Attachment A

Replace page 5.4-1 with attached 5.4-1 through 5.4-5.

5.4 Fuel Storage

BY ALW DATE 11/27/83 SUBJECT FIGURE 4-1 SECT. 2 SHEET 4 OF 8
 CHKD. BY WMM DATE 12/27/83 POOL LAYOUT PROJ. NO. 8369

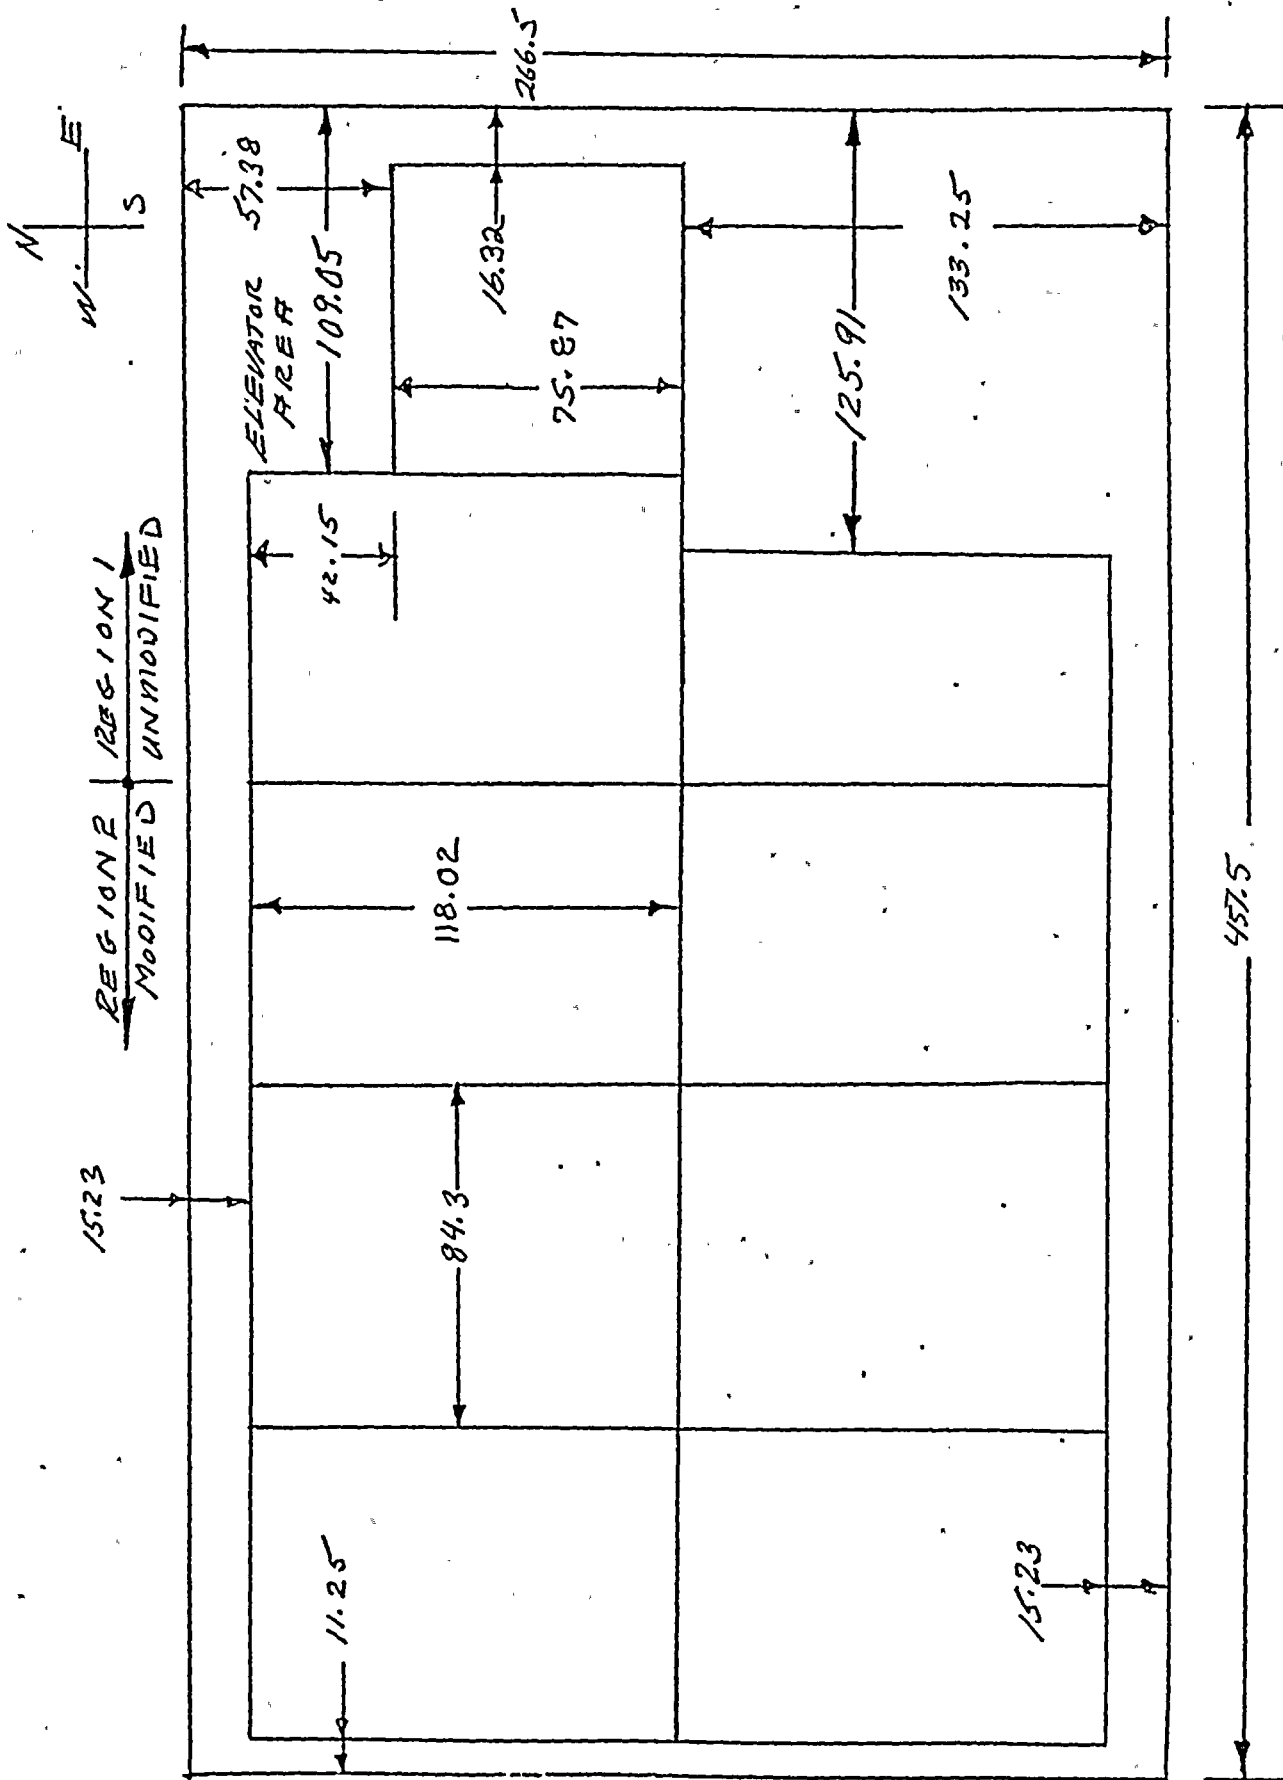
Section 1 provides a description of the modification. As shown in Figure 4-1, the west six racks will be modified to allow storage of spent fuel in what are currently water box locations. These racks will be designated Region 2 and will incorporate neutron absorbing material in each location. Shims are added under the rack bases in Region 2 to provide an increased load transfer area. Sliding is accommodated in the Region 2 racks between the rack and the base support by removal of the bolts between the two (Fig. 4-2). The Region 1 racks are unmodified and their storage density and loads remain the same. In this case sliding would occur between the jack screws at each corner of the support bases and the 11" x 11" plates which rest on the spent fuel pool floor.

There are no calculations for wall loads because, as freestanding racks and bases, due to removal of the wall seismic restraints, there are relatively large dimensions between the racks and walls and consequently small hydrodynamic forces. These approximate dimensions are indicated on Figure 4-1 and are large compared to the maximum sliding distance of .5 inches.

FIGURE 4-4

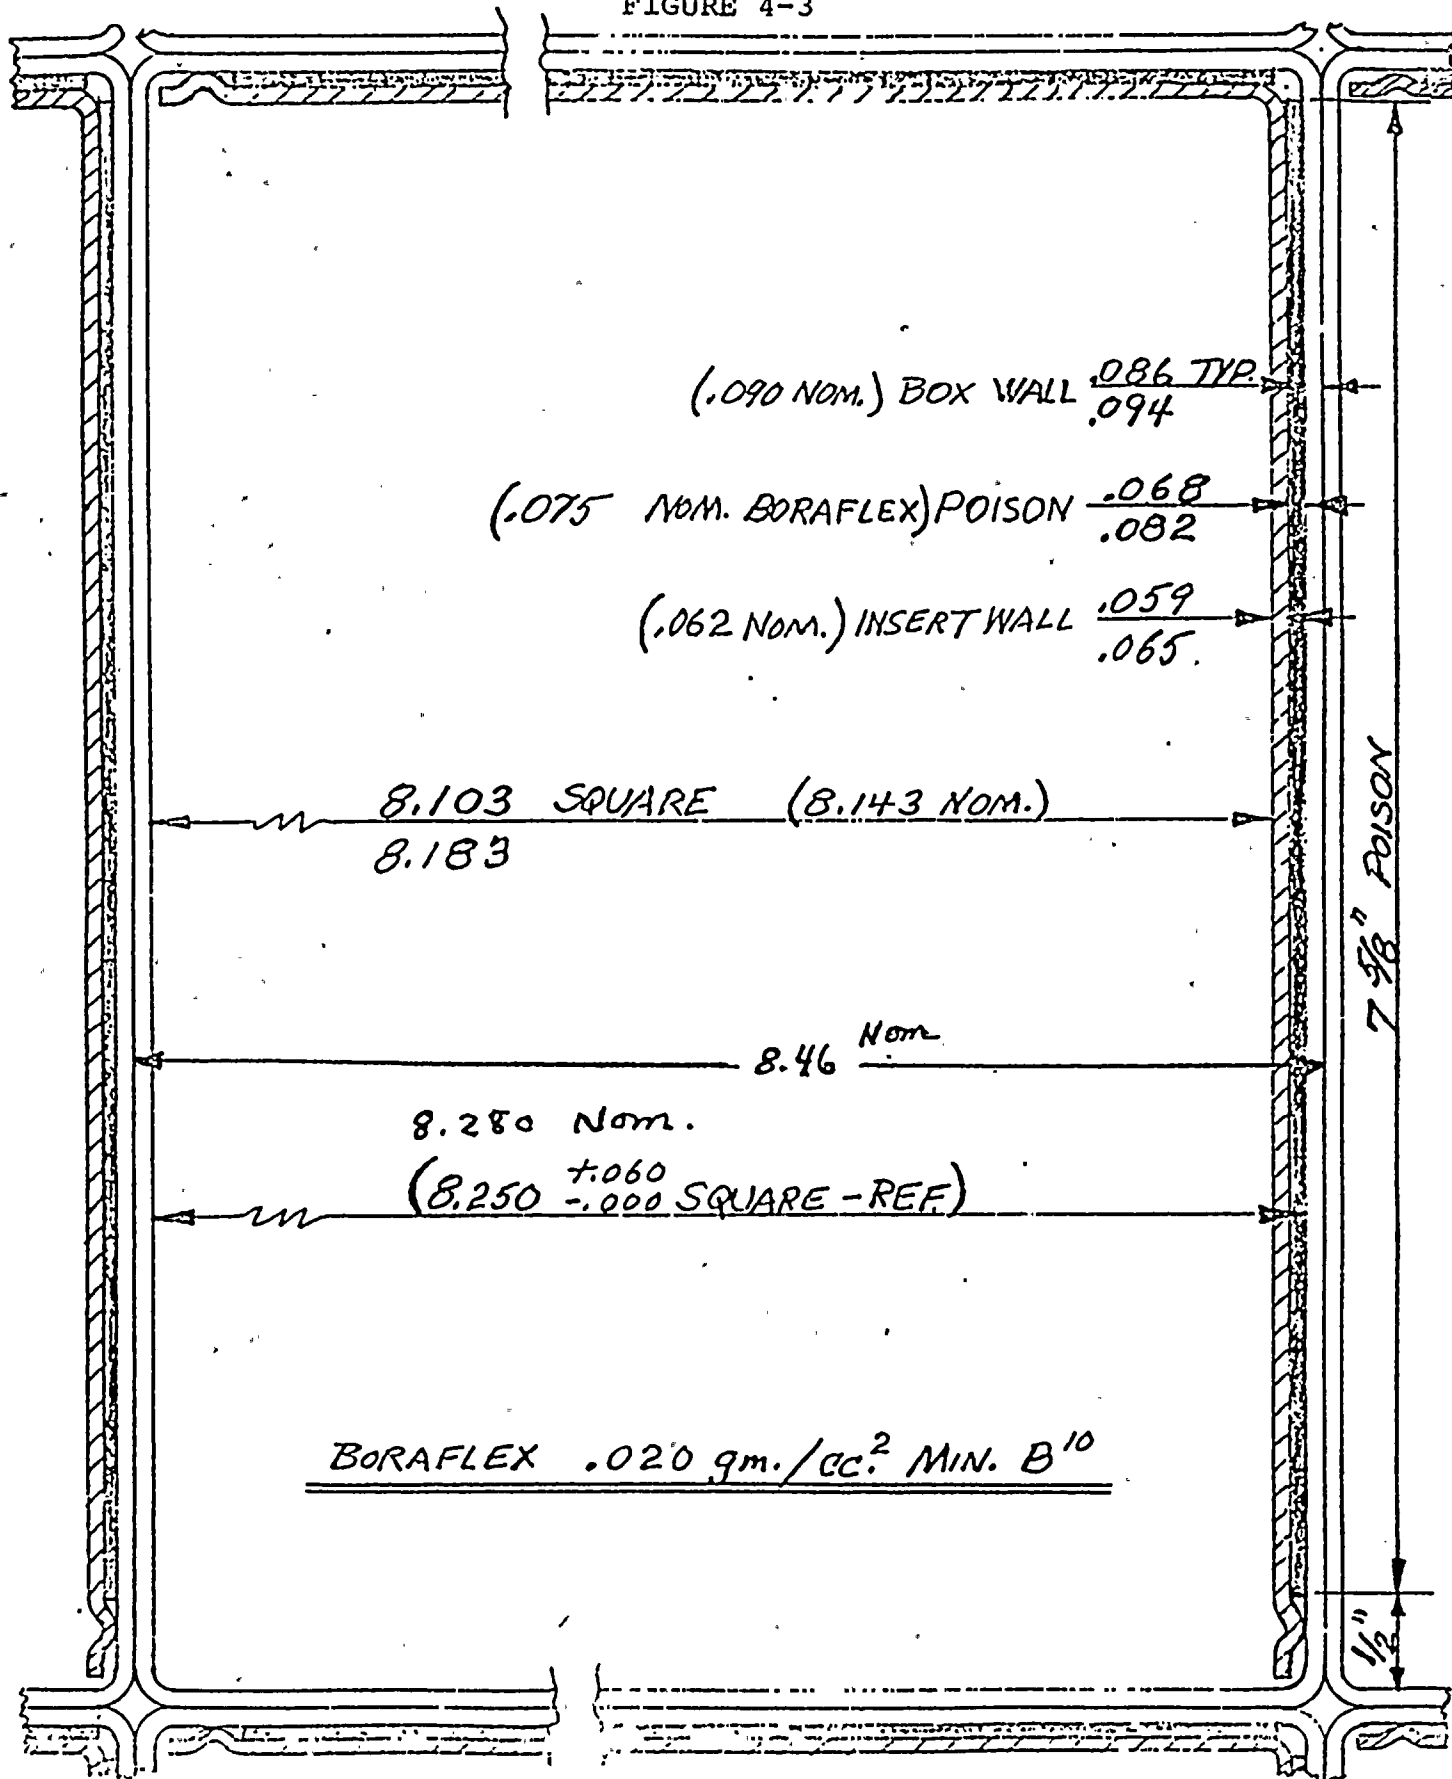
Referring to Figure 4-4, Poison Assembly Installation, the length of the poison material in the cell is 132 inches. This compares to a maximum fuel assembly active fuel length of 142 inches. The ends of the active fuel region will be at a burnup lower than the assembly average. However, this positive reactivity effect will be offset by the increased neutron leakage at the ends of the fuel region. Additional calculations are being performed to quantify the net reactivity effect of the poison configuration. The results of these calculations will be forwarded when available and the poison material region extended if required.

FIGURE 4-9
RACK-BASE SUPPORT

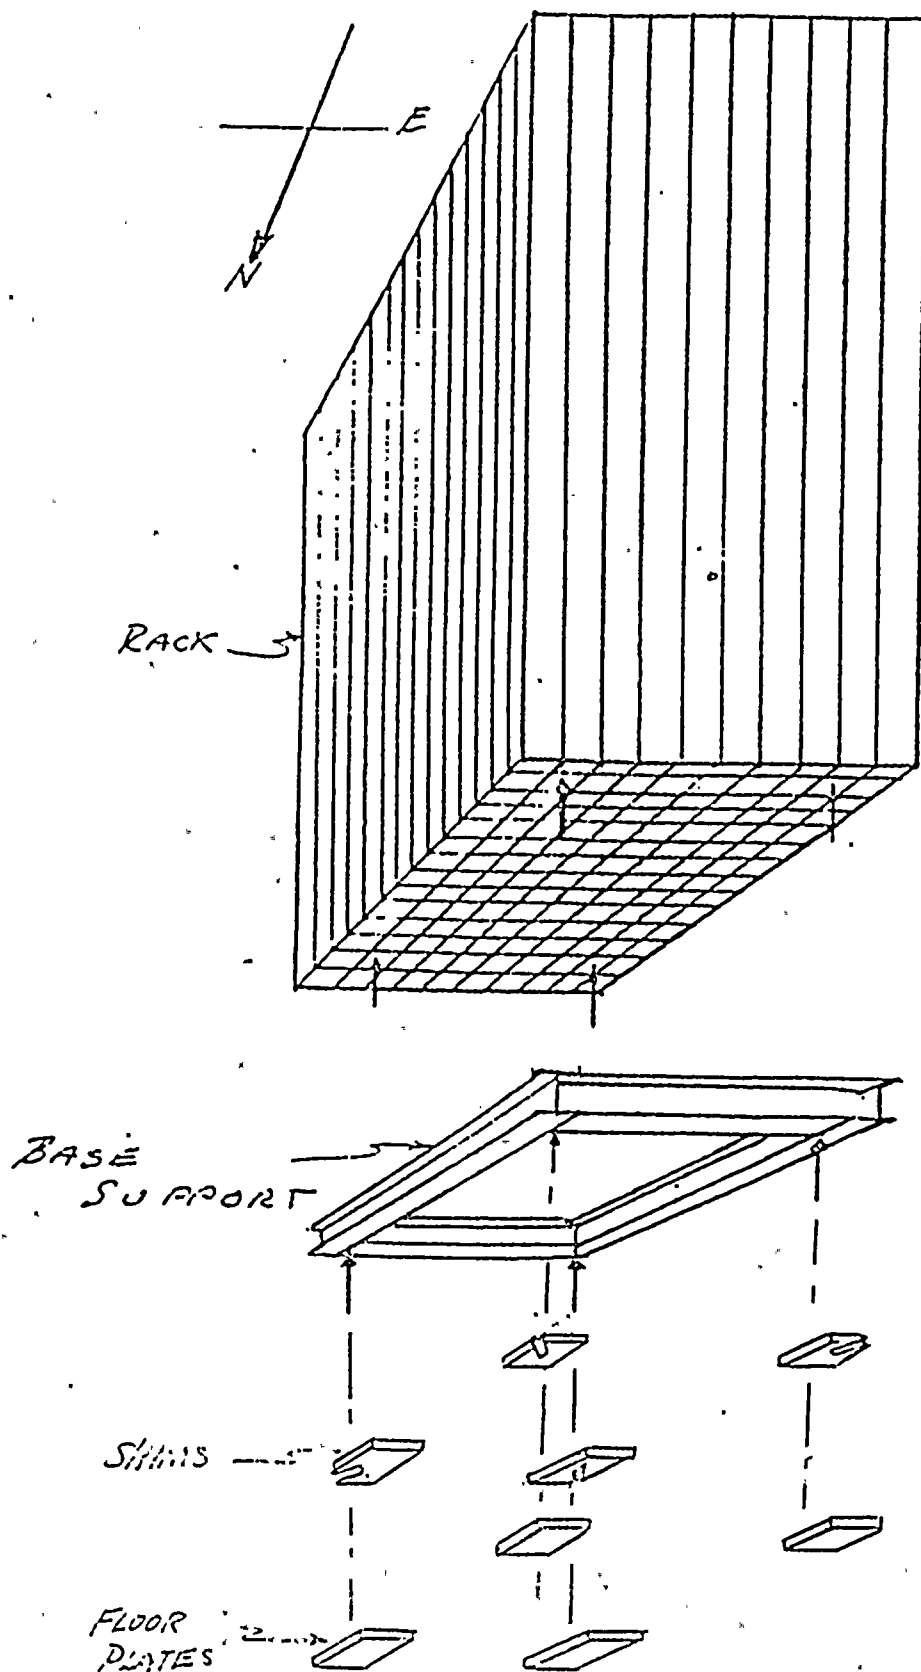
A sketch of rack, base, shims, and floor plates is represented in Figure 4-9. The shims are added between the base and floor plates in order to provide more load carrying area than the present jackscrews.
